RECEIPT DATE: 12/28/17 **ONSITE SEWAGE DISPOSAL SYSTEM**

**RE: OSDS Plan  
17751 Hardy Road**

The OSDS Plan for 17751 Hardy Road has been reviewed with the following comments:

**ONSITE SEWAGE DISPOSAL SYSTEM DESIGN PLAN**  
**LOT 24 WOODCAMP FARMS**  
17751 HARDY ROAD

**ONSITE SEWAGE DISPOSAL SYSTEM DESIGN PLAN**  
**LOT 24 WOODCAMP FARMS**  
 17751 HARDY ROAD  
 TAX ACCOUNT NO.: 04354591  
 TAX MAP: 6 BLOCK: 6 PARCEL: 485  
 4th ELECTION DISTRICT HOWARD COUNTY, MARYLAND

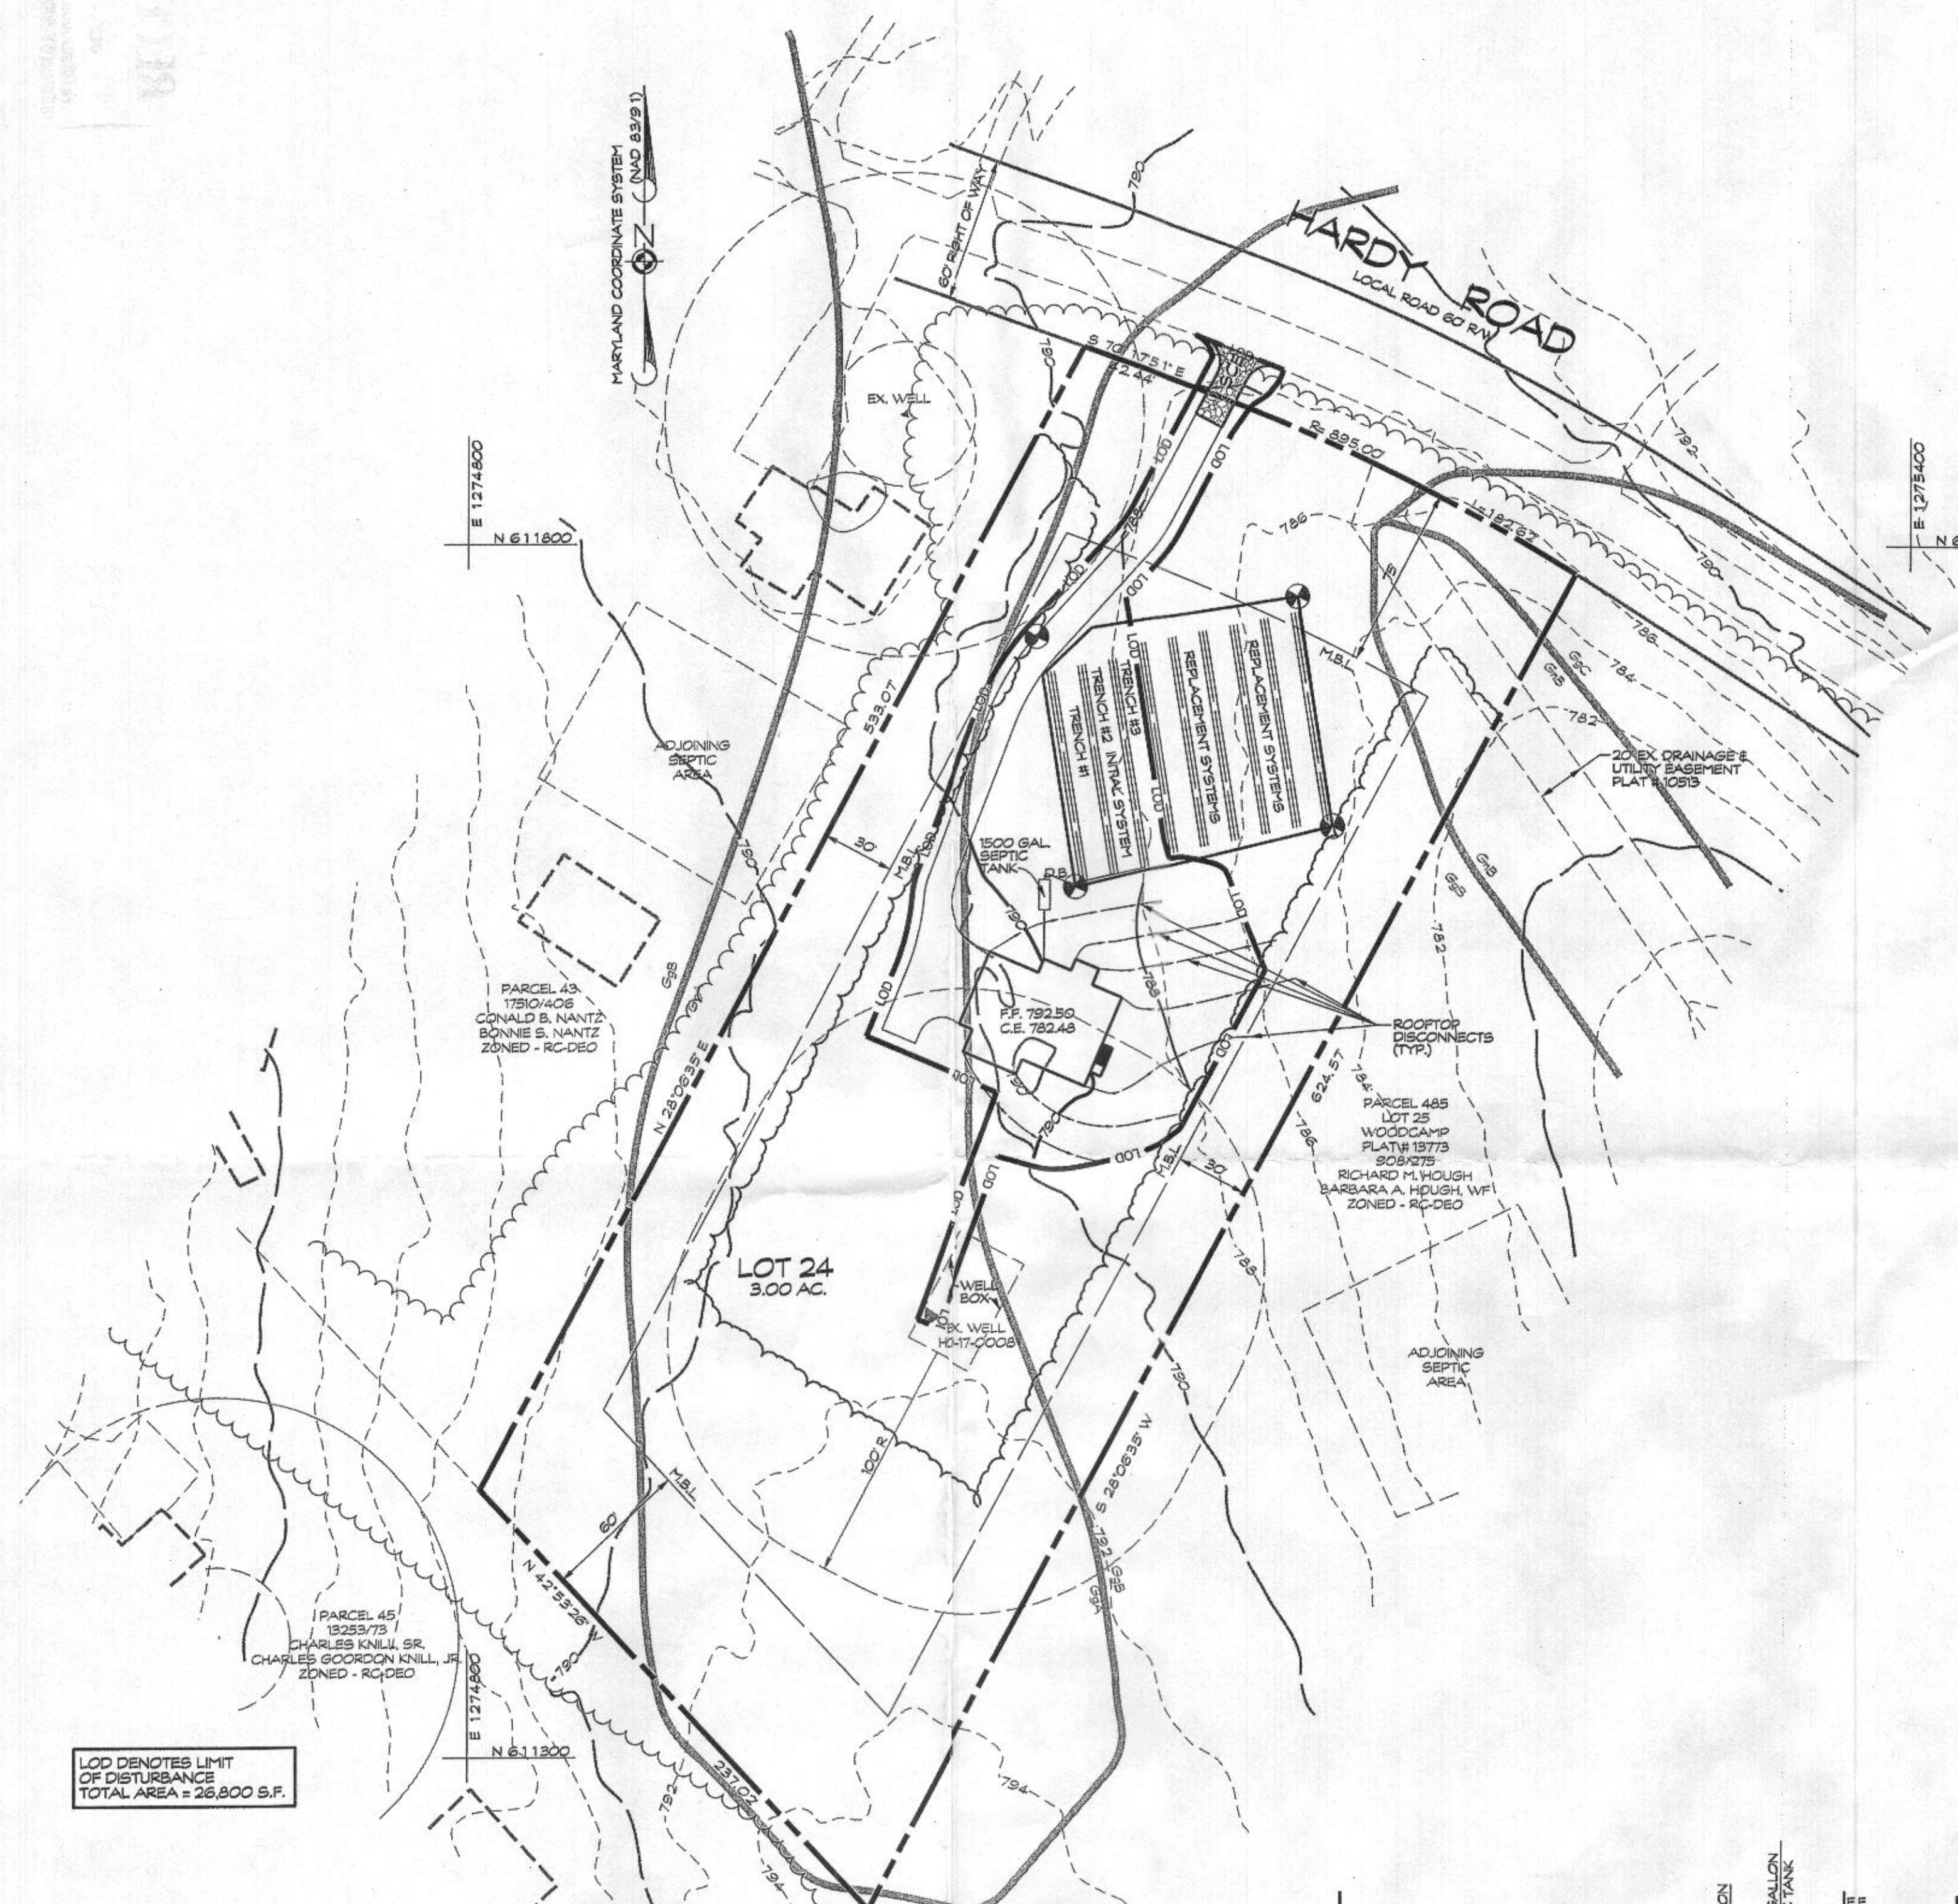
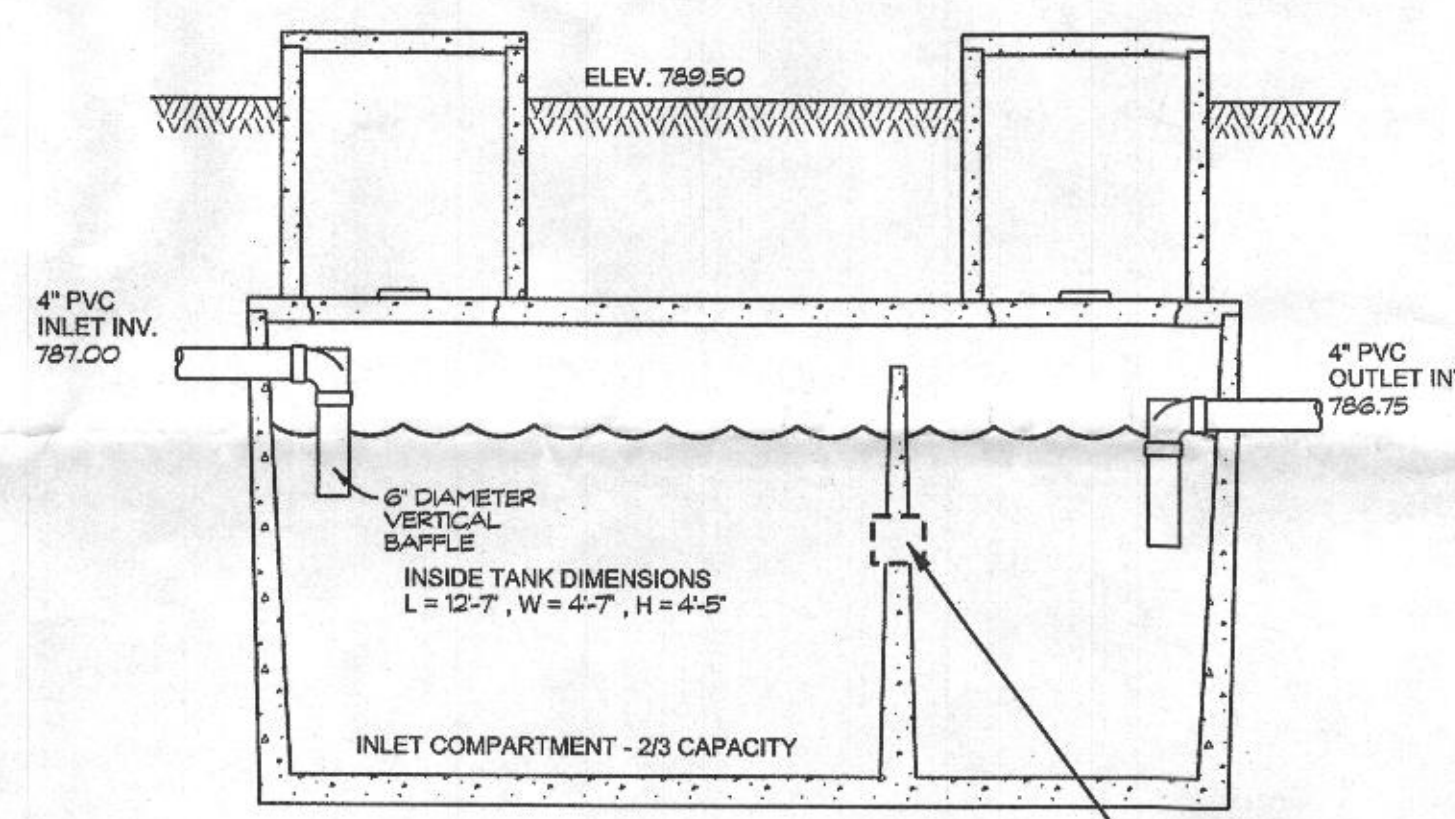
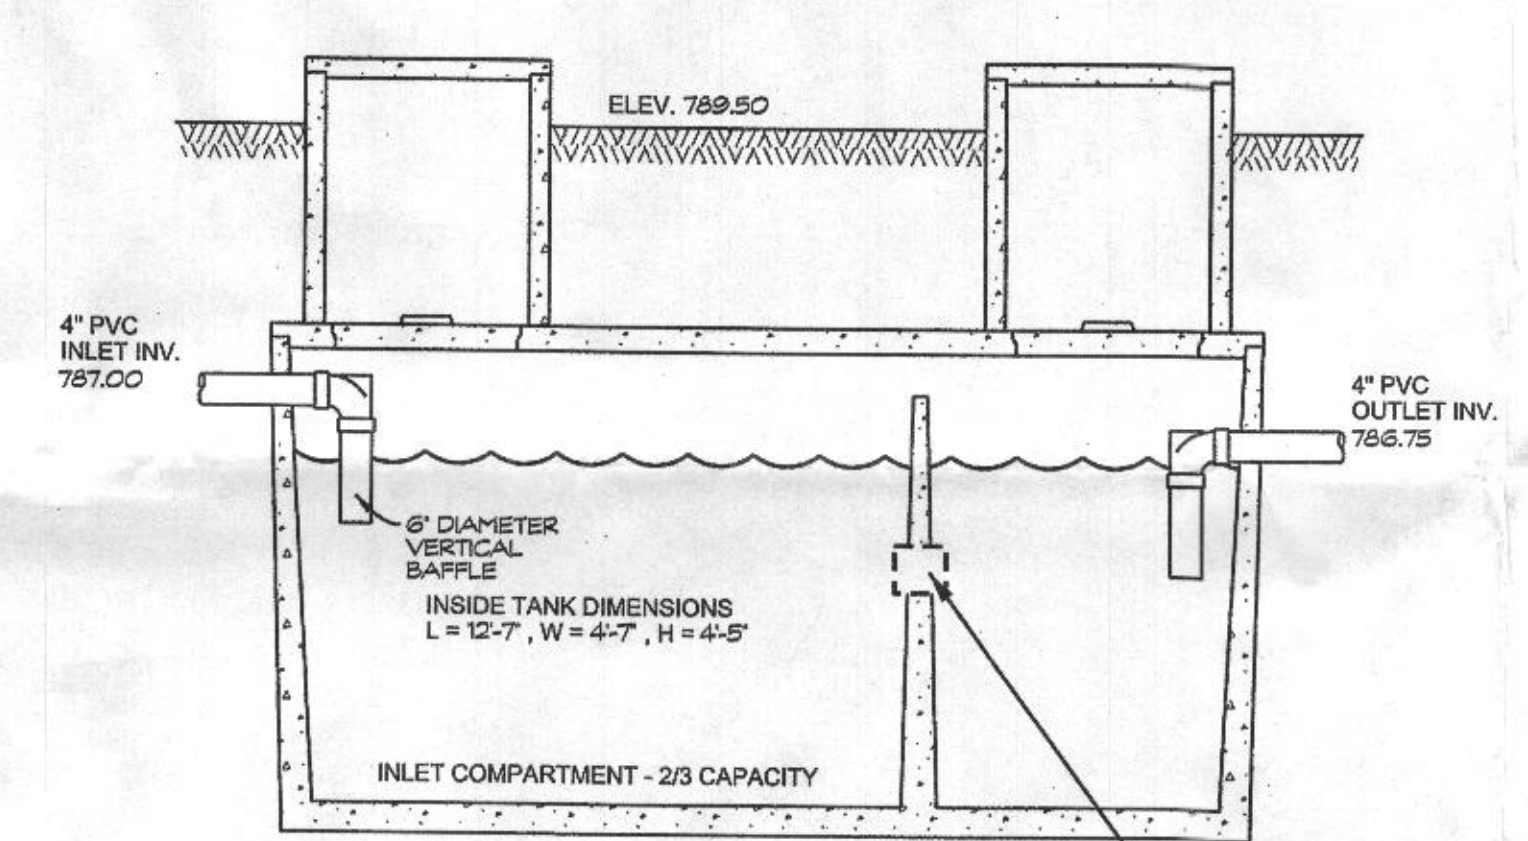
- 1.) Show well box on plan
- 2.) Show 10 foot separation between each trench (spacing is measured edge to edge).

Date	Revisions	Drawn By:	VP
9/14/17	REVISED PER HCHD LETTER DATED 9/12/17	Designed By:	LDA
		Reviewed By:	LDA
		Date:	JUNE, 2017
		Scale:	1" = 50'
		Job No.:	2017144
		Sheet:	1 of 1
